UNITED STATES DEPAR United States Patent and Address: COMMISSIONER F P.O. Box 1450 Alexandria, Virginia 22: www.uspto.gov	Trademark Office OR PATENTS
APPLICATION NO.	FILING DATE	FIRST NAMED INVENTOR	ATTORNEY DOCKET NO.	CONFIRMATION NO.
10/763,115	01/22/2004	Roy K. Lim	PC883.00/4906-017	6097
62644 7590 08/18/2009 MEDTRONIC Attn: Noreen Johnson - IP Legal Department 2600 Sofamor Danek Drive MEMPHIS, TN 38132			EXAMINER	
			COMSTOCK, DAVID C	
			ART UNIT	PAPER NUMBER
· ,			3733	
			MAIL DATE	DELIVERY MODE
			MAIL DATE	DELIVERIMODE

Application No.	Applicant(s)				
	10/763,115	LIM, ROY K.				
Office Action Summary	Examiner	Art Unit				
	DAVID COMSTOCK	3733				
The MAILING DATE of this communication appears on the cover sheet with the correspondence address Period for Reply						
 A SHORTENED STATUTORY PERIOD FOR REPLY IS SET TO EXPIRE <u>3</u> MONTH(S) OR THIRTY (30) DAYS, WHICHEVER IS LONGER, FROM THE MAILING DATE OF THIS COMMUNICATION. Extensions of time may be available under the provisions of 37 CFR 1.136(a). In no event, however, may a reply be timely filed after SIX (6) MONTHS from the mailing date of this communication. If NO period for reply is specified above, the maximum stat

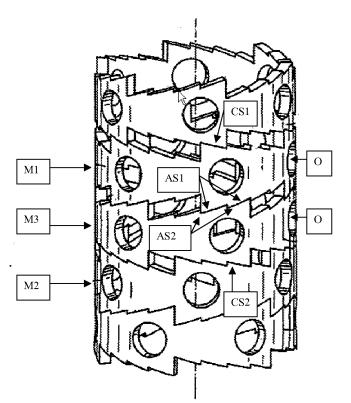
Claims 25, 27, 29 and 31 are rejected under 35 U.S.C. 102(a) as being

anticipated by Conchy (FR 2,817,463) with reference to the figure below.

Conchy teaches a device to space vertebral members comprising: a first

member M1 having an interior side with first and second angled sections AS1 and an

exterior side with a first contact surface CS1; a second member M2 having a second

interior side and a second exterior contact surface CS2; a third member positioned

between the first member and the second member, the third member M3 having a first side with first and second angled sections AS2 positioned towards the angled sections AS1 of the first member M1, and a second side positioned towards the interior surface of the second member M2, the device positionable between a first orientation with the angled sections of the first member disengaged from the angled sections of the third member M3 and having a first height extending between the first contact surface CS1 and the second contact surface CS2, and a second orientation (shown) having the angled sections AS1 of the first member M1 engaged with the angled sections AS2 of the second member M2 and having a second height between the first contact surface CS1 and the second contact surface CS2, with the second height being greater than the first height.

Claims 32, 37, 38 and 46 are rejected under 35 U.S.C. 103(a) as being

unpatentable over Conchy (With reference to the aforementioned figure) in view of

Conchy teaches a device to space vertebral members comprising: a first member M1 and a second member M2 each having an exterior side CS1/2 and an interior side, the interior sides having ramped surfaces AS1/2 positioned at an angle relative to the exterior sides, the device positionable between a first orientation with the ramped surfaces AS1/2 disengaged and having a first height extending between the exterior surfaces CS1/2, and a second orientation (shown) having the ramped surfaces AS1/2 engaged and having a second height between the exterior surfaces CS1/2, with the second height being greater than the first height.

Hence Conchy teaches all of the limitations of the present invention except a delivery device connected to at least one of the first and second members and having an elongated shape to position the device between the vertebral members; and a deployer operatively connected to one of the first and second members to give movement of the first member relative to the second member.

Applicant's arguments filed 05 May 2009 have been fully considered but they are not persuasive with respect to the claims that remain rejected. The amendment to independent claims 25, 32, 37 and 46 can be satisfied by the applied art in that along a vertical axis, the members and spacer not only have a non-continuous, discrete shape (i.e., tubular) but also have a free distal end and proximal end that face in opposing Application/Control Number: 10/763,115 Art Unit: 3733
